MANKATO PLANNING COMMISSION
Regular Meeting March 25, 2026 - 6:00 p.m.
Intergovernmental Center
Council Chambers

Site Plan Review Comments

The Site Plan and Traffic Committee reviewed the request at their February 10th, 2026 meeting and the following comments were provided. The applicant subsequently replied, as shown in italics:

S. FRONT STREET MIXED USE REDEVELOPMENT
MANKATO, MINNESOTA - 03/20/2026
ISG PROJECT NO. 26-33587

SHEET
C5-10

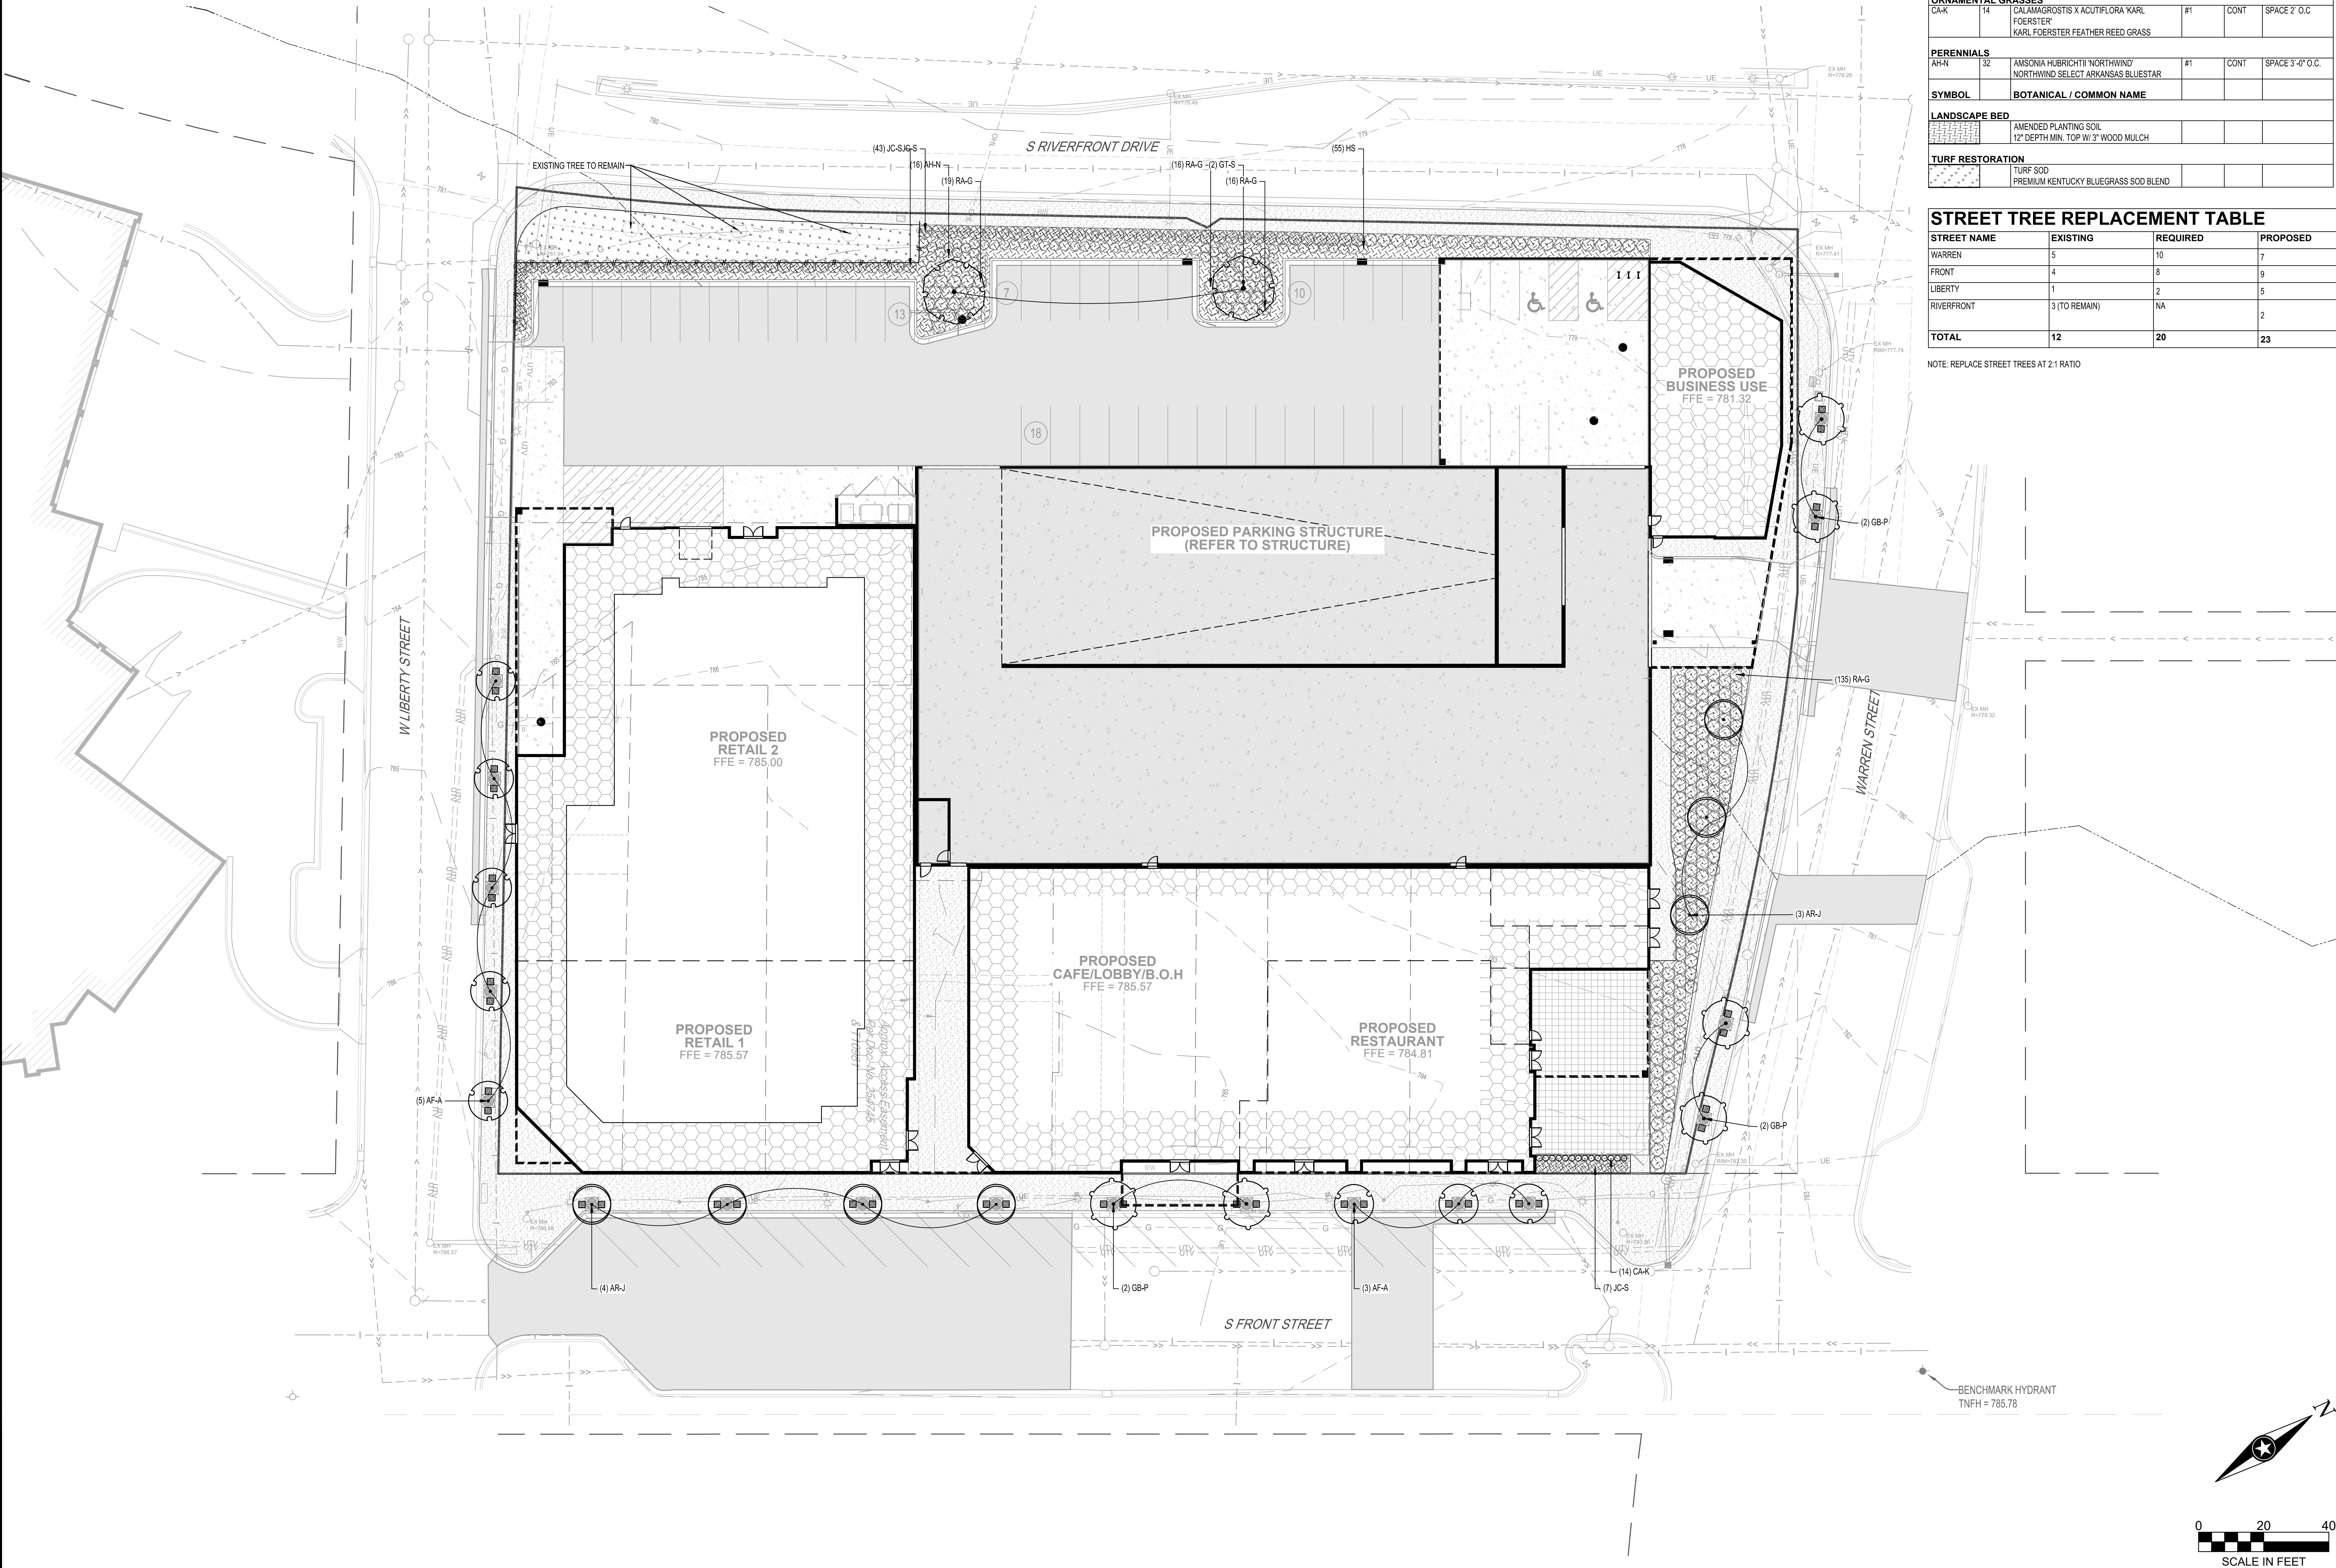
- d. The applicant shall submit a plan to screen the parking in the surface parking area. *ISG Response: Landscape screening is shown on sheet C5-10 and is continuous along surface parking. Sea Green Junipers are proposed to provide year-round screening at a consistent 4' height once fully grown.*

ISG Response: Landscape screening is shown on sheet C5-10 and is continuous along surface parking. Sea Green Junipers are proposed to provide year-round screening at a consistent 4' height once fully grown.

PLANTING DETAILS

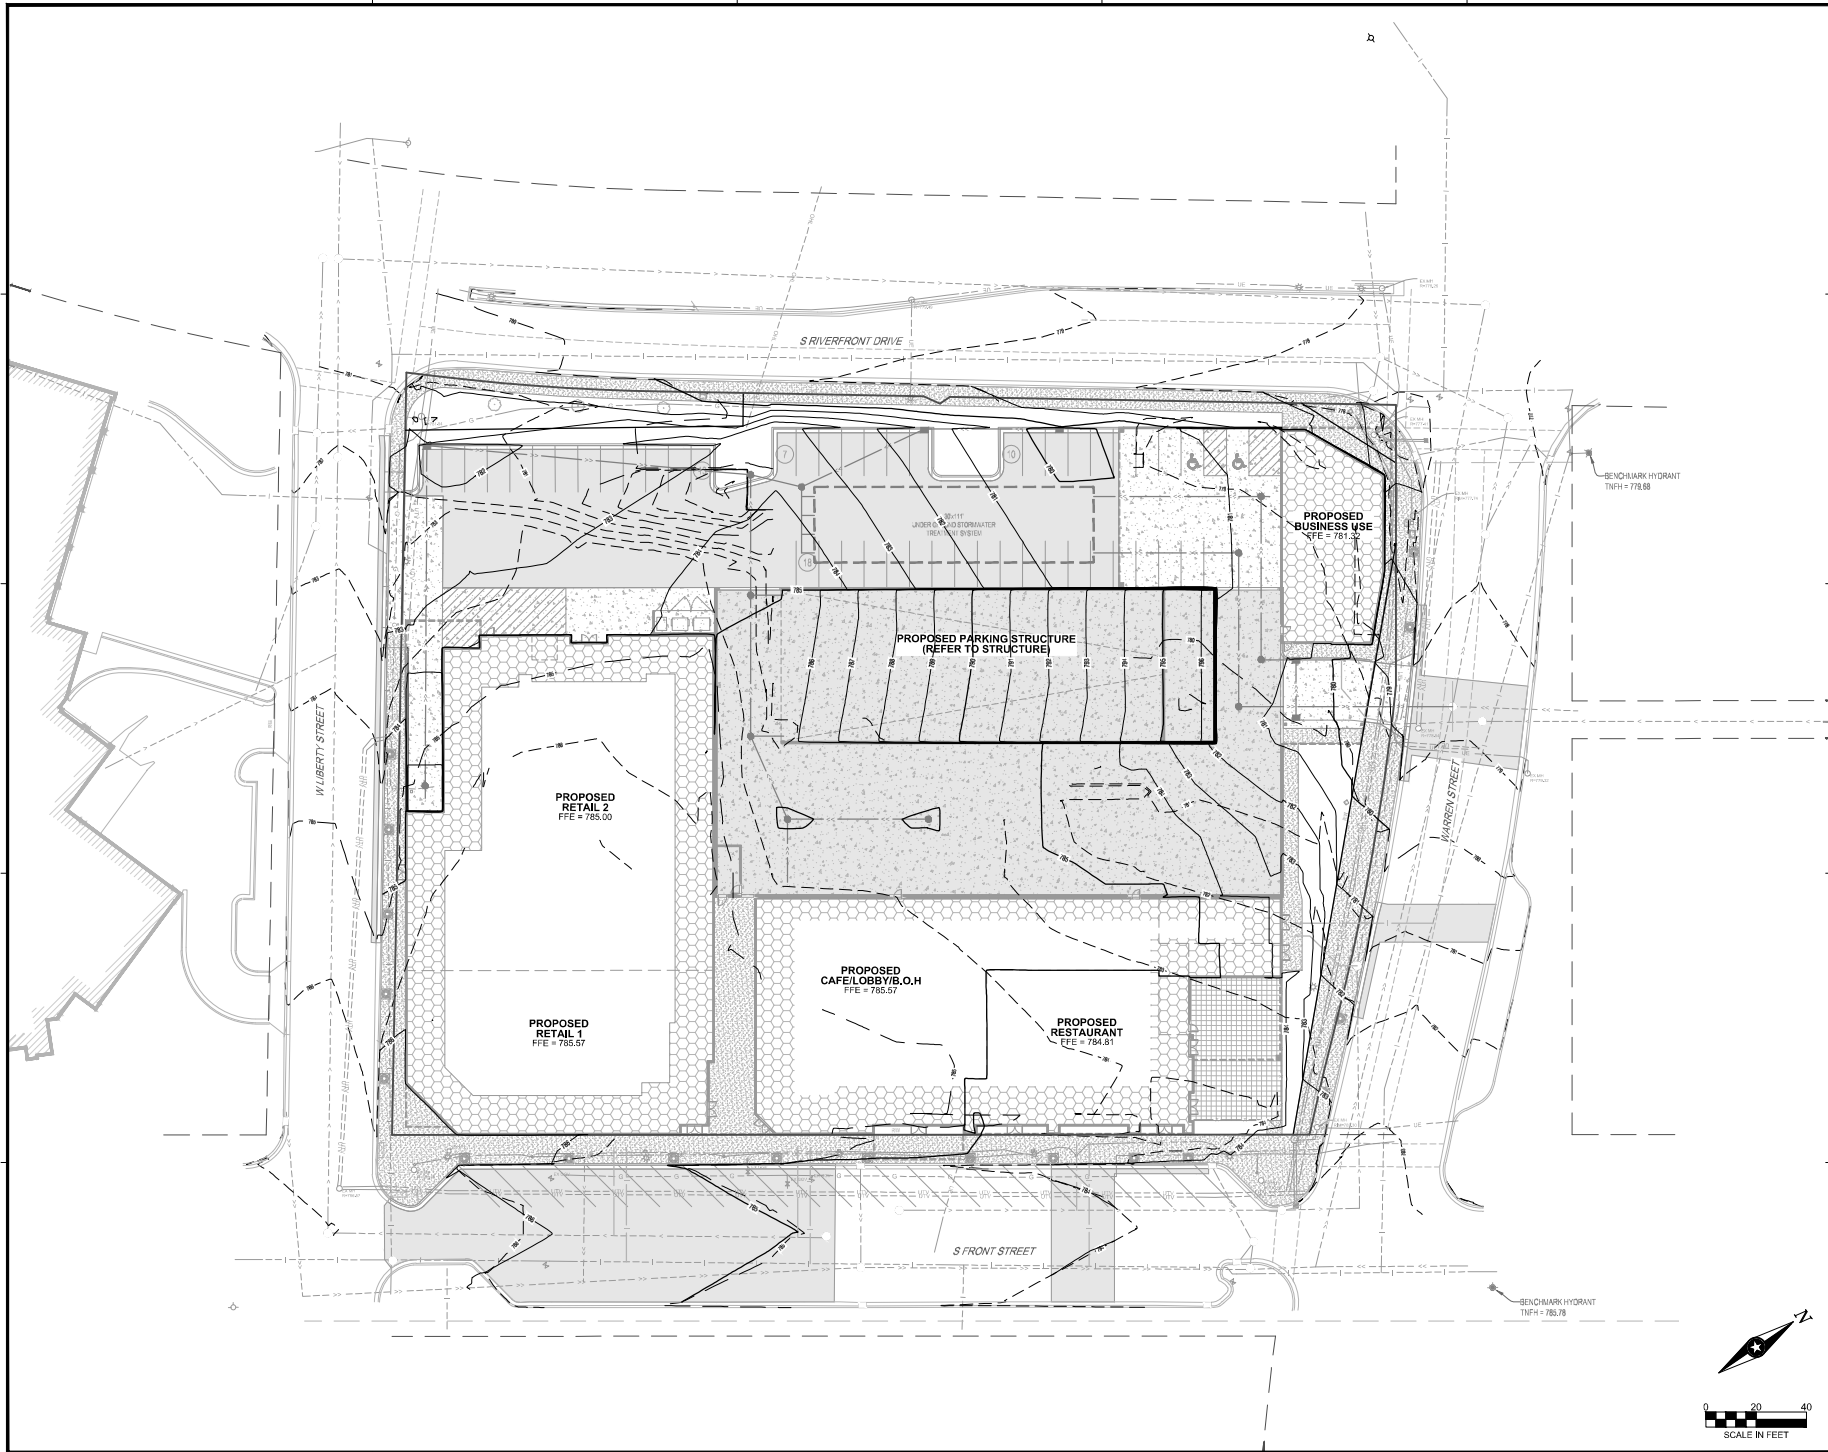
- l. Applicant shall provide planting details for the proposed landscaping plan in accordance with Mankato City Code. *ISG Response: Refer to added sheet C5-20.*

ISG Response: Refer to added sheet C5-20.
